Product Change Notification - SYST-21LMFR637

ERRATA - PIC32MX1XX/2XX/5XX 64/100-pin Family Silicon Errata and Data Sheet Clarification

PIC32MX1XX/2XX/5XX 64/100-pin Family Silicon Errata and Data Sheet Clarification

17. Module: I/O Port - Initial Pin State

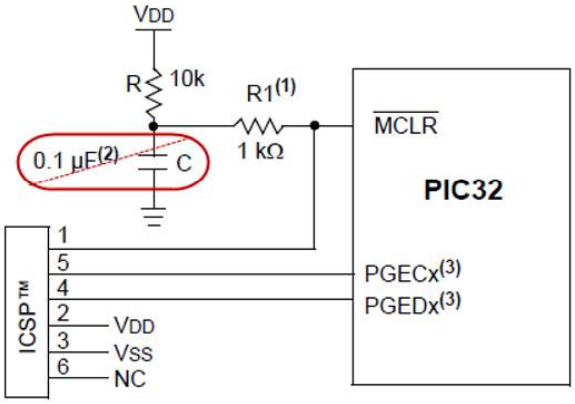
On power-up depending on the VDD ramp rate, the I/O pins can be in an active random output driving state if $\overline{MCLR}$ is active until a BOR event.

If, not using an external reset supervisor IC or equivalent, remove the $\overline{MCLR}$ capacitor as shown below, and retain the $\overline{MCLR}$ Pull-up resistor.

If using an external reset supervisor IC or equivalent, increase the value of the VCAP capacitor to ≥47 µf ceramic or solid tantalum capacitor with an ESR ≤ 1 ohm.
